**ALERT SERVICE BULLETIN**

**SUBJECT: REVISION "A" TO ALERT SERVICE BULLETIN ASB 206L-08-150:  
POWER TURBINE RPM (N2) STEADY STATE OPERATION  
AVOIDANCE, INTRODUCTION OF.**

NO. 206L-08-150

REV A

Figure 1 – Typical 206LT Instrument Panel Layout

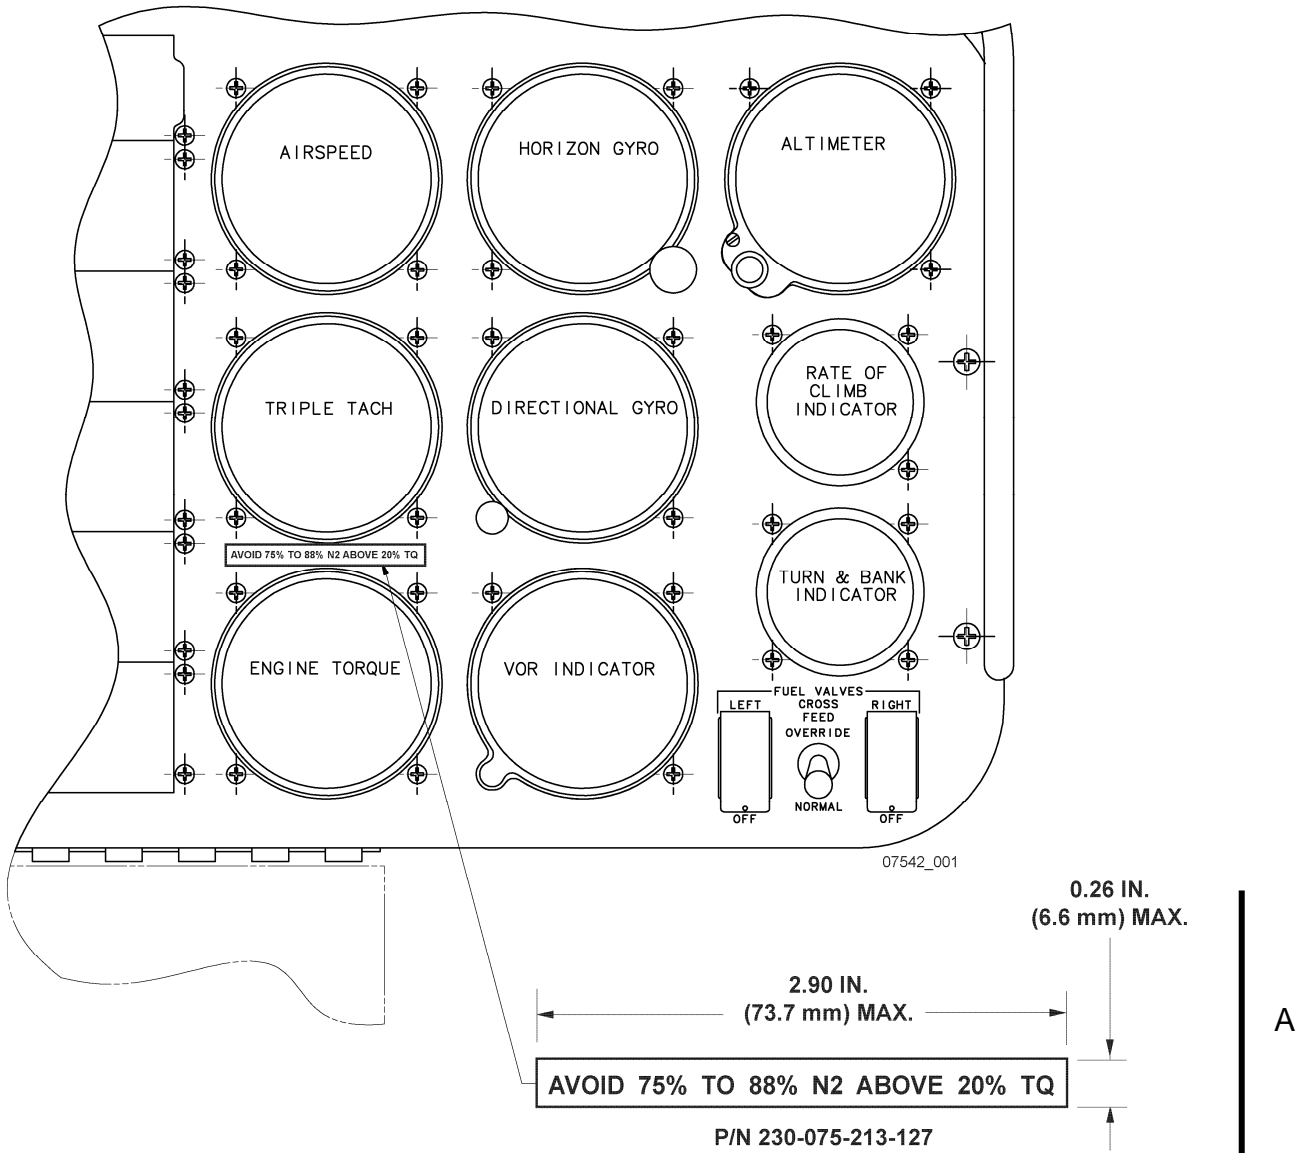
Revision "A" to this bulletin introduces a new decal removing the "60 SEC MAX" wording.

1. The decal may be locally manufactured using lettering of white color (No. 17875) on black background color (No. 17038). Characters to be 10 point Spartan blackfont. Color per FED STD 595. The text for the decal is detailed in Figure 1 and should be in capital letters. It is permissible to use existing decal provided the "60 SEC MAX" wording is cut and removed.

1. Install decal 230-075-213-127 on the instrument panel as shown in Figure 1,  
below the NR/N2 triple tachometer. Sealer C-349 shall be applied over the  
installed decal.
